PCN-20210616 TE0821-01 eMMC Change and Product Update

Company	Trenz Electronic GmbH
PCN Number	PCN-20210616
Title	TE0821-01 eMMC Change and Product Update
Subject	BOM change
Issue Date	2021-08-10

#3 Change Ferrite Beads (L1, L2, L3, L4, L5, L7, L9, L10, L11, L12) BKP0603HS121-T to MPZ0603S121HT000

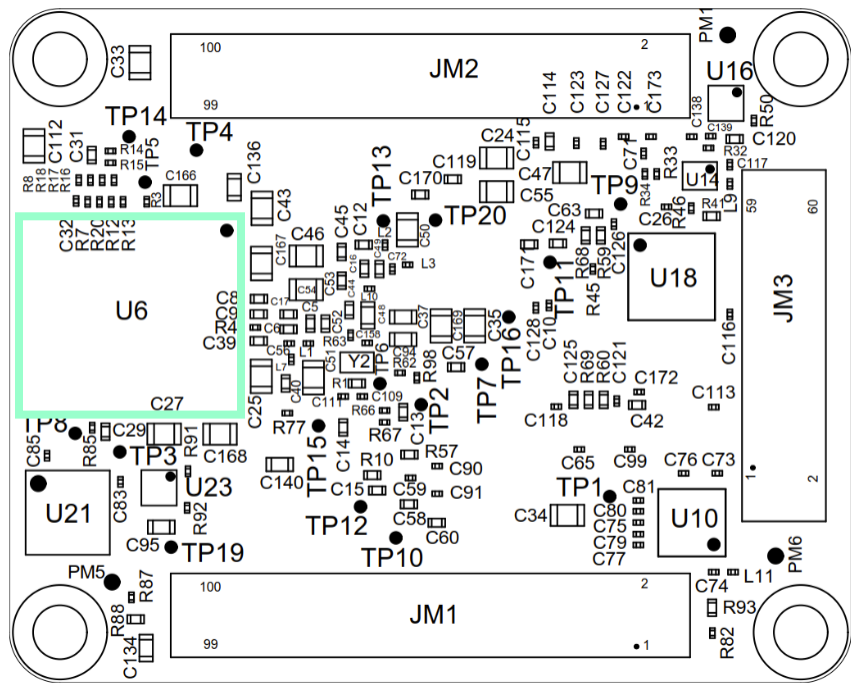
Type: BOM change
Reason: Part is NRND and EOL announced.
Impact: None. DC resistance decreased from 150mOhm to 130mOhm, rated current increased from 0.85A to 1A.

Locate eMMC (U6) on bottom side of PCB:

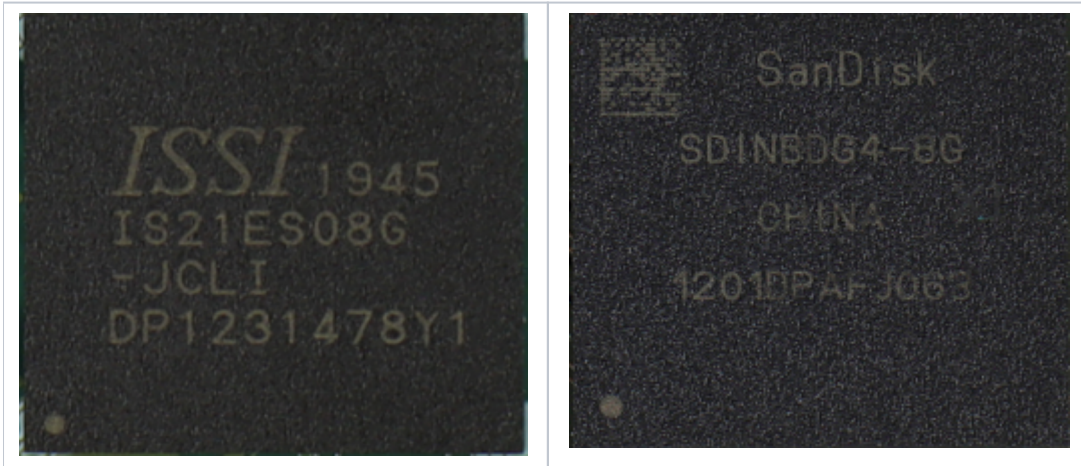
#1 Change eMMC (U6) from IS21ES08G-JCLI / IS21ES64G-JCLI to SDINBDG4-8G-XI2 / SDINBDG4-64G-XI2

old	new
IS21ES08G-JCLI or IS21ES64G-JCLI	SDINBDG4-8G-XI2 or SDINBDG4-64G-XI2
